Request for Additional Information

Edmondson Park Frasers Town Centre
Town Centre East

Submitted to Liverpool City Council
On behalf of Frasers Property Australia

01 February 2018 | 15895

Figure 4 Design Solution proposed for NE Level 1 podium

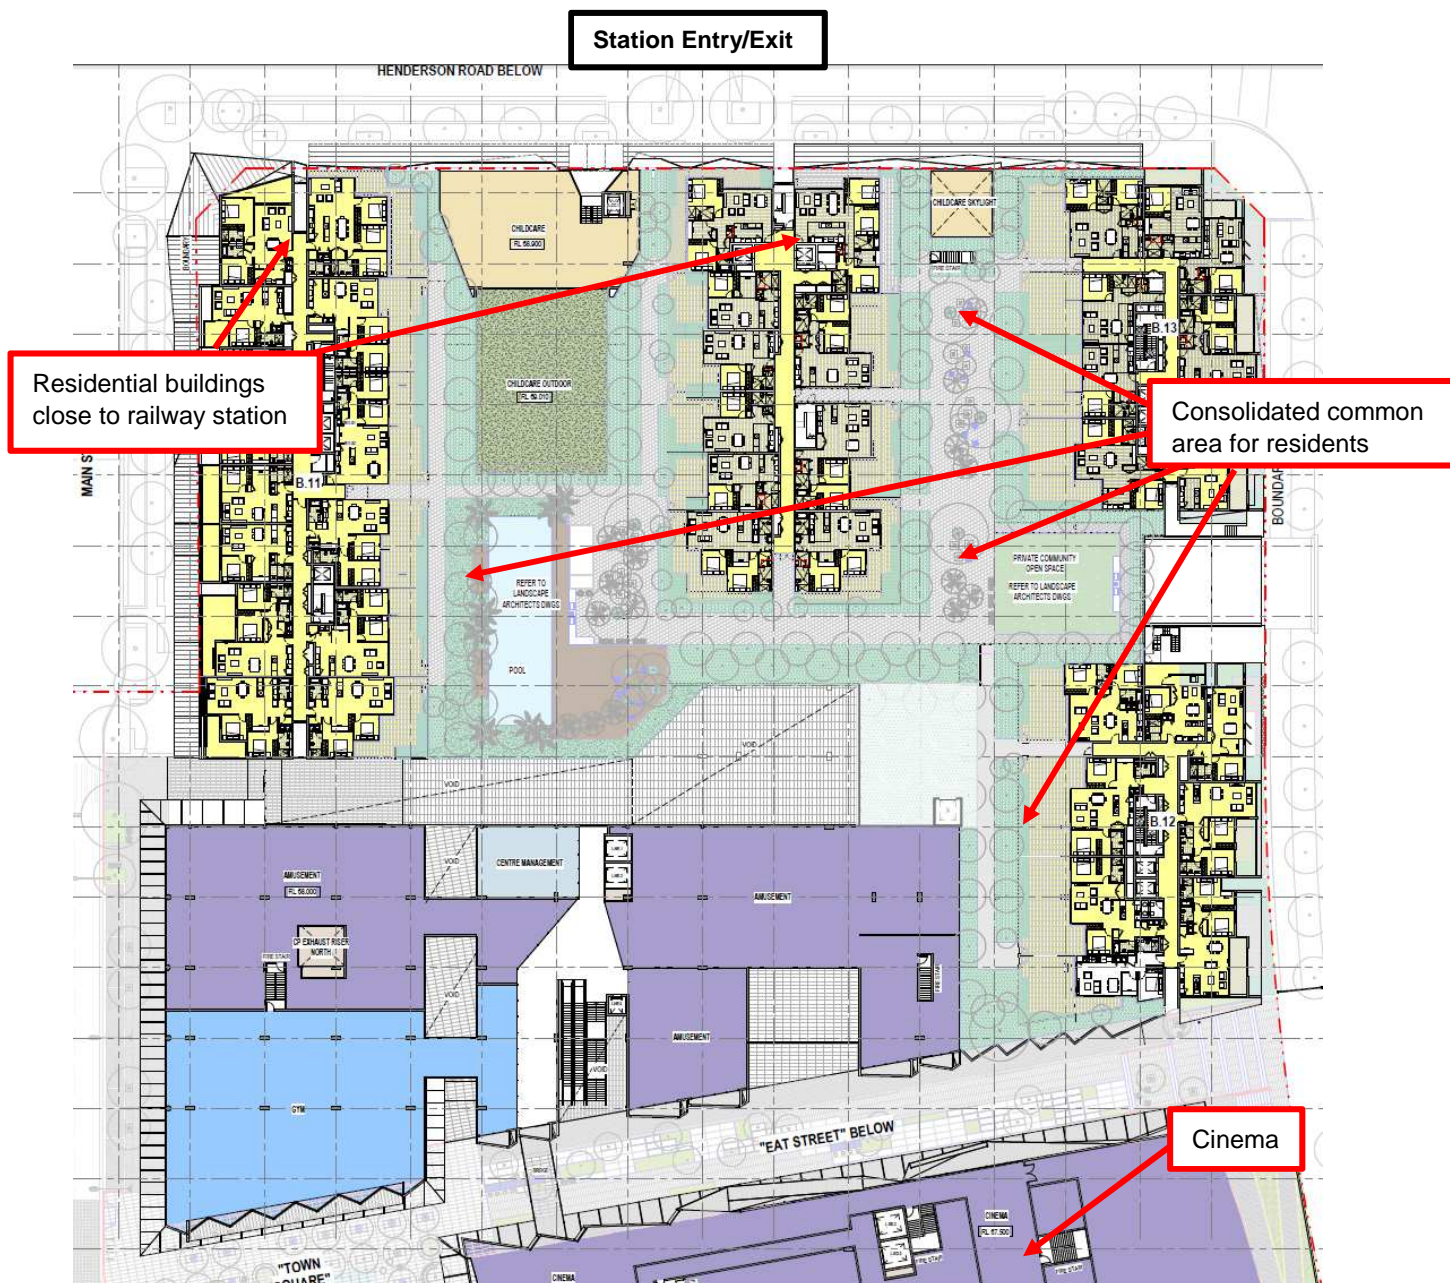
The illustrative design scheme (**Figure 3**) incorporated a north-south pedestrian link between Henderson Road and Eat Street that crossed the NE Level 1 podium with substantial stairs at each end. This is reflected in the structure plan. This link was never considered to be located at Ground Level and would have provided a link to the Cinema entry on the podium of the NE Quadrant..

Under the illustrative design submitted with MOD 4 the cinema would have crossed the entire NE quadrant and separate the residential buildings on Soldiers Parade from the rest of the quadrant (refer to **Figure 3**). This enabled the inclusion and co-location of the pedestrian link over Level 1 between Henderson Road and Eat Street.

Following design development, an enhanced design solution relocated the cinema allowing residential buildings 10 – 13 to be located close to the train station at the north of the site. In turn, a consolidated common area was made possible across the NE quadrant uniting all the residential buildings and making the NE podium a united and larger space, providing greater amenity for residents (**Figure 4**).

These changes have prevented the inclusion of the podium level north-south pedestrian link which would sever the common area and introduce a publicly accessible walkway between private residential areas. Accordingly, the through site pedestrian link at Level 1 is not possible. An assessment of the alternative solution is provided at Section 2.5(2).

Figure 8 Corner of Greenway and Main Street
Source: HDR

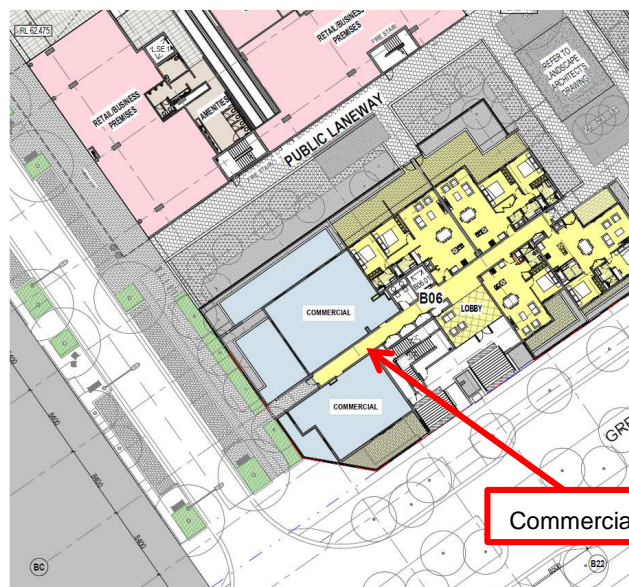
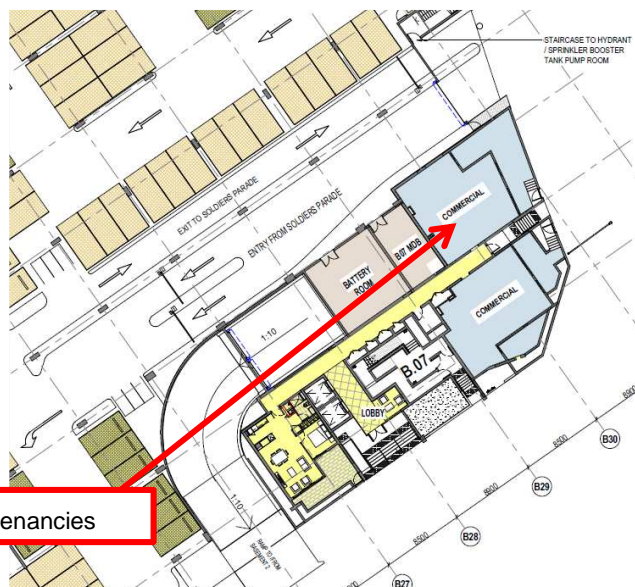
3. Active edges along the ground floor built form south of Eat Street and north of the Pedestrian Laneway fronting Soldiers Parade

The plans have been amended to accommodate commercial offices at the corner of Greenway and Soldiers Parade, further activating this part of Soldiers Parade, consistent with the Design Guidelines (Figure 8 and Figure 9 and Appendix A).

Consistent with design solution DS2.3 the corner of Greenway and Main Street and Greenway and Soldiers Parade has been amended from residential to commercial floor space. Amended plans are provided at Appendix A.

Figure 12 Main Street indicative Section details

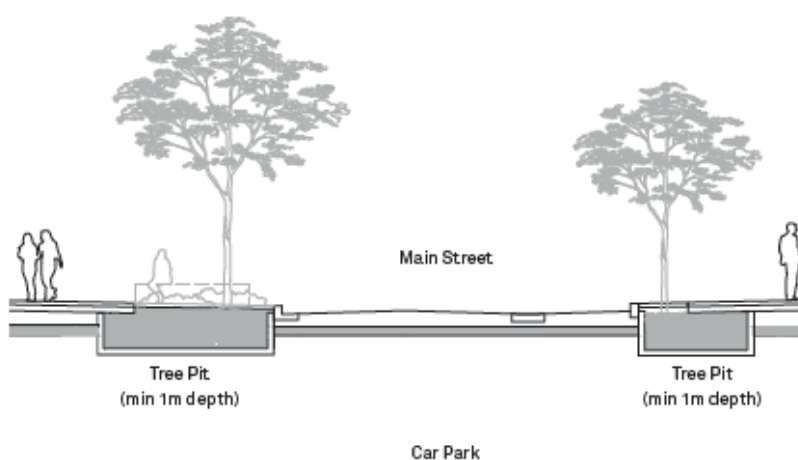
4. **Main Street to be designed to provide “generous pockets of plantings”. Considering that no deep soil zones have been provided within the eastern portion of the town centre core there is not considered to be the ability to provided sufficient planting to suite the local climate and address the potential impacts associated with the urban heat island effect**

As shown at **Figure 12** Main Street includes landscaping within pit infrastructure that has a minimum 1 metre depth in volumes provided regularly along the length of Main Street, above and below the pavement, acting in the role of deep soil. As shown at **Figure 12** a below ground car park has always been considered in the design of the Town Centre with landscaping provided on structure in suitably sized pits to support healthy tree growth.

Figure 15 Level 1 Common Open Space

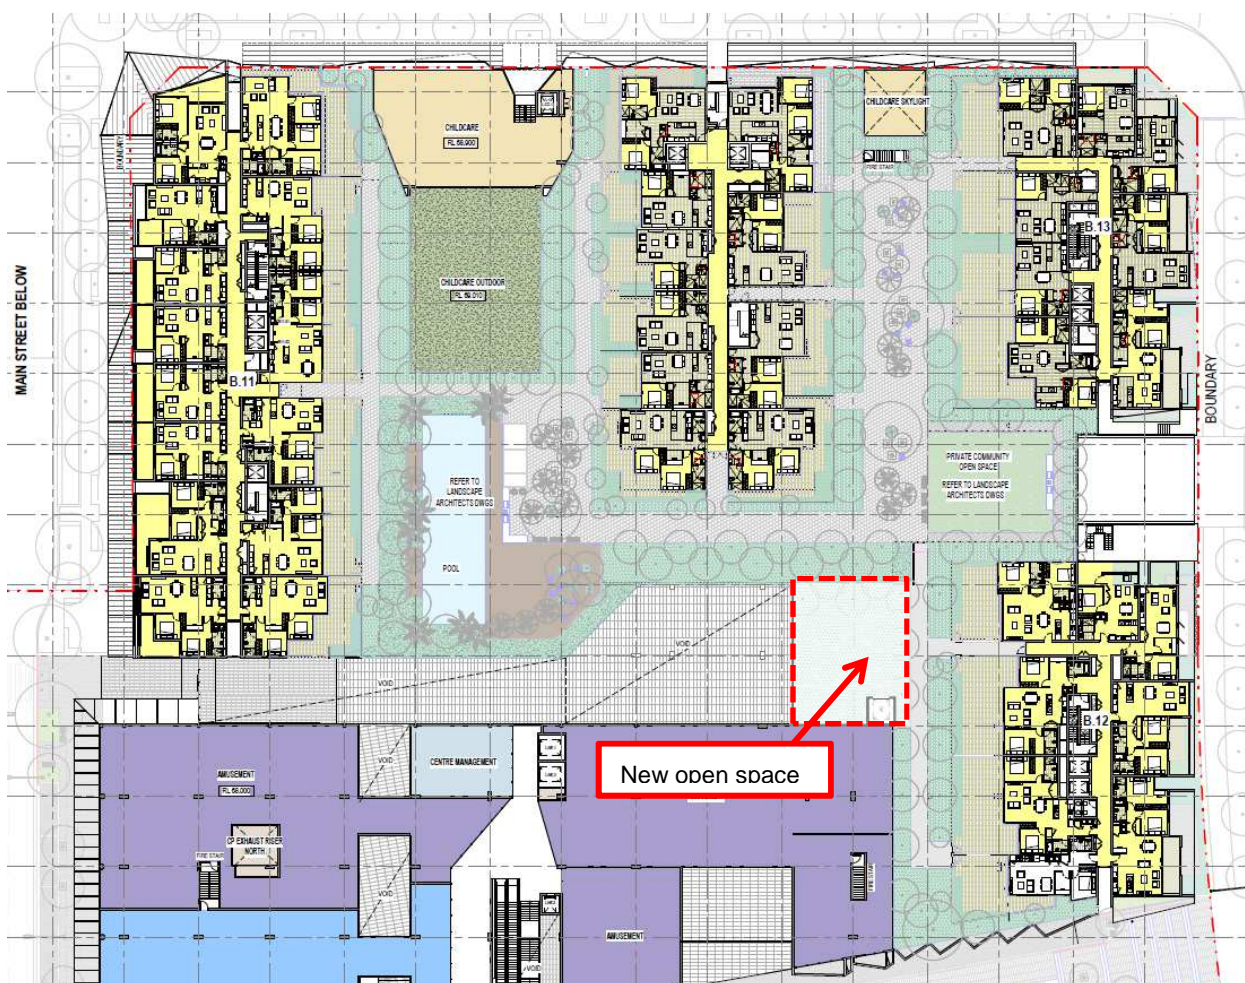
1. **3D – Communal and public open space:** *The RFB's in both quadrants do not comply with the Communal Open Space (COS) design criteria, of particular concern are the RFB's in the south-east quadrant. The proposal shall be amended to fully comply with the ADG and provide a minimum of 25% of COS for the RFB's.*

Further design development has enabled increased provision of common open space on Level 1 of the NE quadrant as shown on amended Architectural plans at Appendix A. This area is highlighted at Figure 15 below where the amusement tenancy has been replaced with landscaping. Amended Landscape Plans are provided at Appendix P.

Incorrect calculations were provided with the SEE that is clarified by this response. Objective 3D-1 of the ADG requires an adequate area of communal open space be provided to enhance residential amenity and to provide opportunities for landscaping. Design criteria 1 sets the minimum provision of communal open space at 25 percent.

Figure 34 Town Centre East Minor and Fine Grain Links

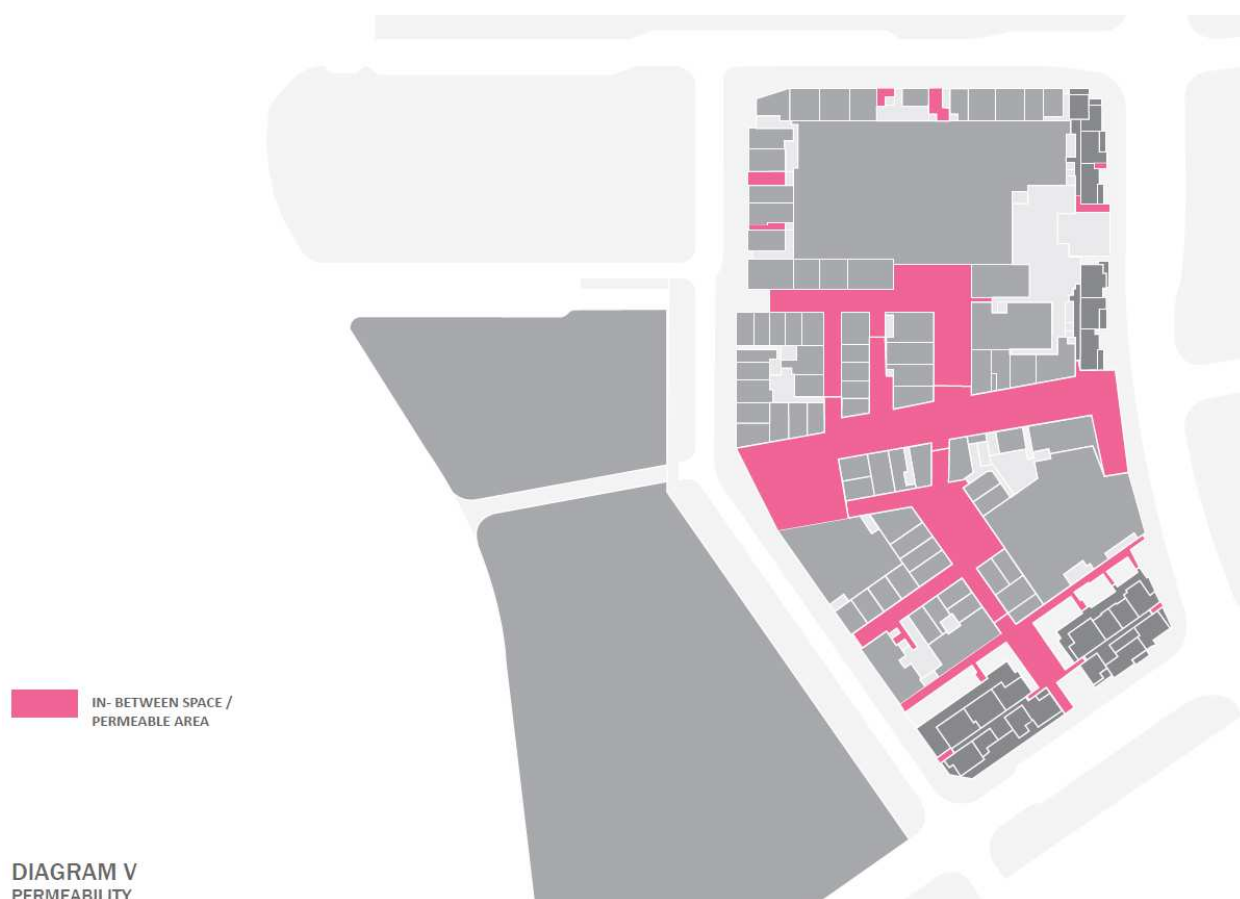
As discussed above the development does not provide optimal pedestrian legibility, walkability, permeability and comfortable movement due to the omission of a pedestrian link from the station to the east street as per the master plan. This is considered to reduce the hierarchy of pedestrian permeability and fine grain connections, which detracts from the creation of a town centre and a 'sense of place'. There is considered to be over emphasis on Main Street as the focus of pedestrian activity into the town centre from the train station. The applicant is required to adequately demonstrate how the above principles of the TCG have been achieved by the proposal in this context.

Delivery of the street network achieves the principle for the Town Centre to provide streets, pedestrian and cyclist paths that are interconnected, legible and permeable and that facilitate convenient, safe, and comfortable movement. The minor and fine grain links are highlighted at **Figure 34** which is consistent with the Illustrative Design (**Figure 32**).

The pedestrian laneway between Henderson Road and Eat Street shown in the illustrative Master Plan (**Appendix G**) traverses the north-east podium at Level 1 with a bank of stairs at either end. As outlined at Section 2.1(2), design changes have prevented its inclusion. The alternative design solution for the NE quadrant has introduced Building 10 and increased the provision of common open space for residents in the location where the pedestrian link was previously. Despite not providing the pedestrian link, the proposal remains consistent with the relevant performance criteria.

Figure 37 Green Link (East) elevation

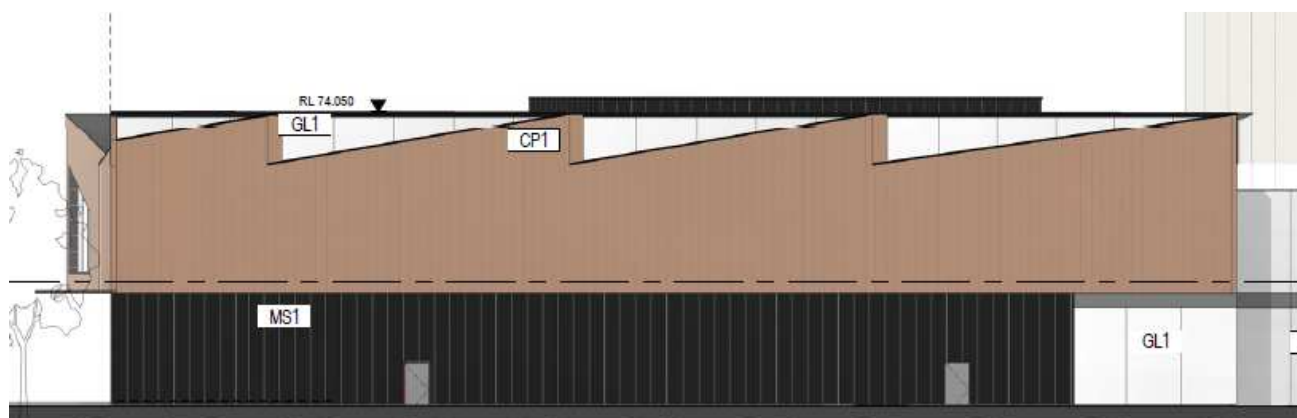
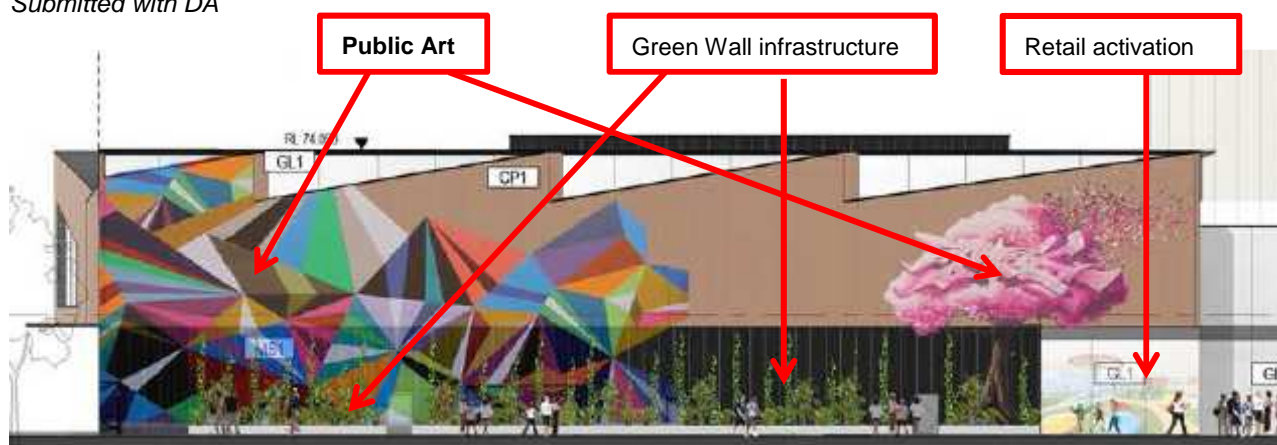
- ***Retail uses will utilise, and take advantage of, external areas, including level 1 balconies and terraces, to achieve enhanced activation throughout the Town Centre Core***

Notwithstanding, additional public art and green wall infrastructure is proposed along the northern façade of the Green Link to further enliven this space consistent with the proposed indoor/outdoor play strategy proposed for the Green Link. Refer to the revised elevation plan for the Green Link at Appendix A and B and reproduced at Figure 37 and Figure 38 below.

Figure 47 Location and access to end of trip facilities

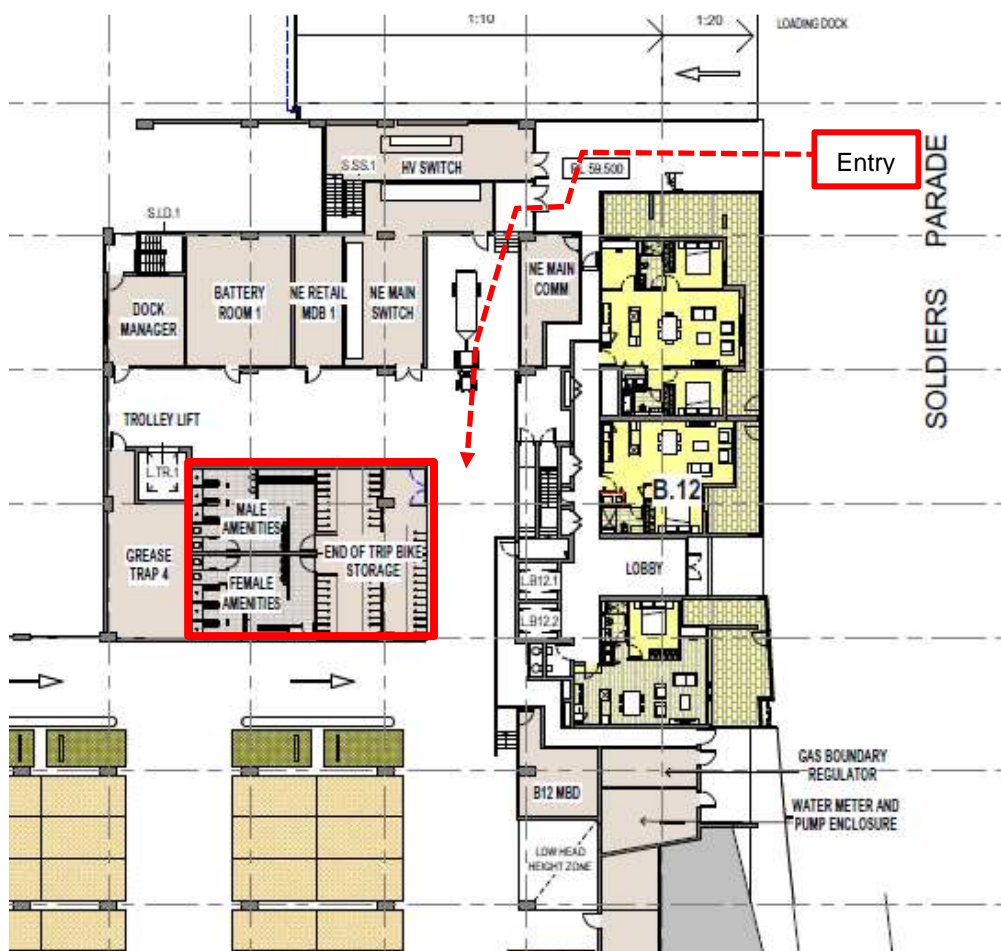
The applicant is required to provide information that demonstrates how the above design solution of the TCG has been achieved by the proposal for assessment.

The end of trip facilities including bike storage and change facilities are co-located on Basement Level 1 behind Building 12 (refer to Architectural Drawing DA17). Access to this space is made from Soldiers Parade as shown in **Figure 47** below.

Figure 53 Internal versus external spaces

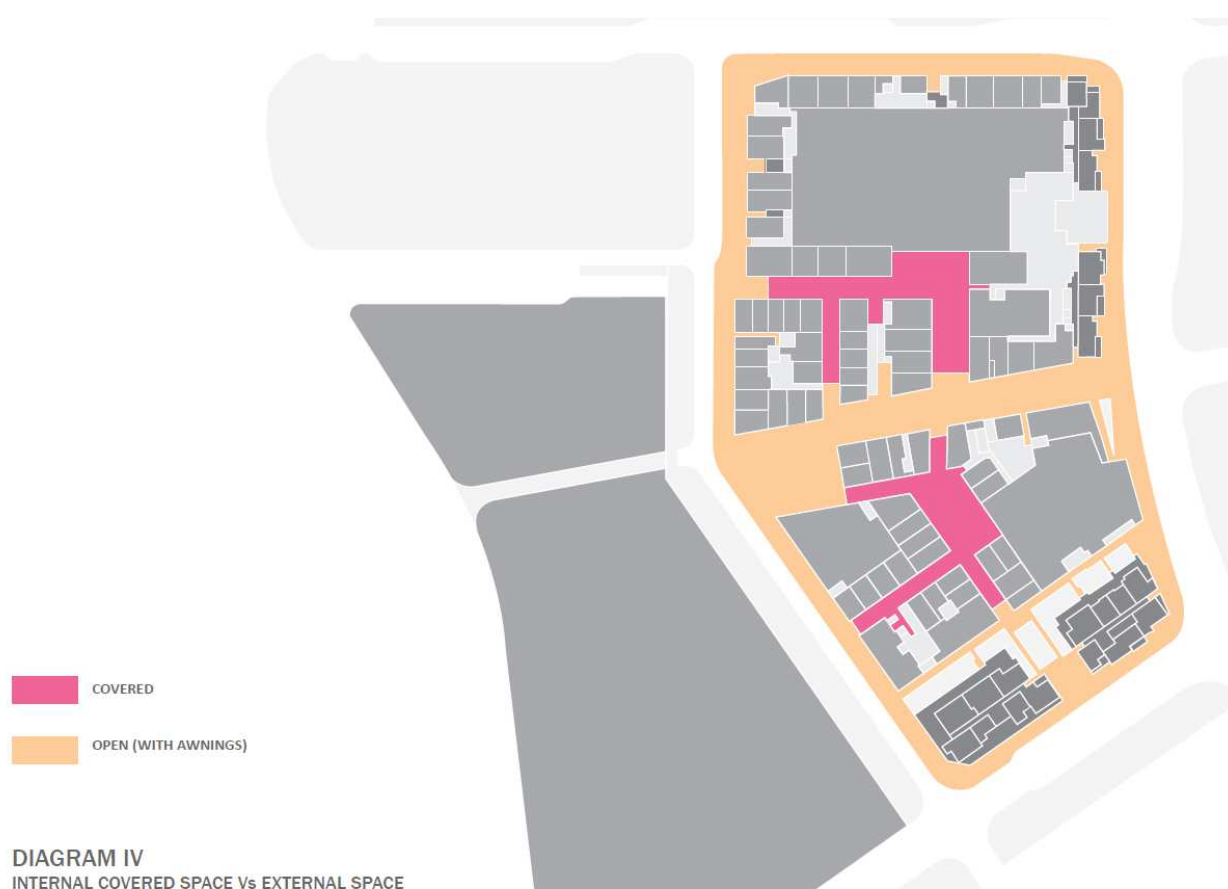
- *The SWCPP have raised concern that the proposal may be susceptible to becoming a 'shopping centre' as opposed to its intended function as a town centre. The panel has raised concern that a 'sense of place' will not be created at the site, especially as the design appears to be centred on large commercial tenants (anchor tenancies), which may detract from social interaction within the town centre.*
- *Accordingly, the applicant is advised to adequately demonstrate how the street/pedestrian network and commercial layout proposed will provide dynamic social interaction within the town centre.*

Figure 53 shows the extent of internal versus internal (covered) spaces. It shows that the Town Centre is dominated by external facing environment that features awnings to provide protection from the elements to provide a comfortable environment to spend time. This is at odds with a traditional shopping centre that would typically be dominated by an enclosed air conditioned space.
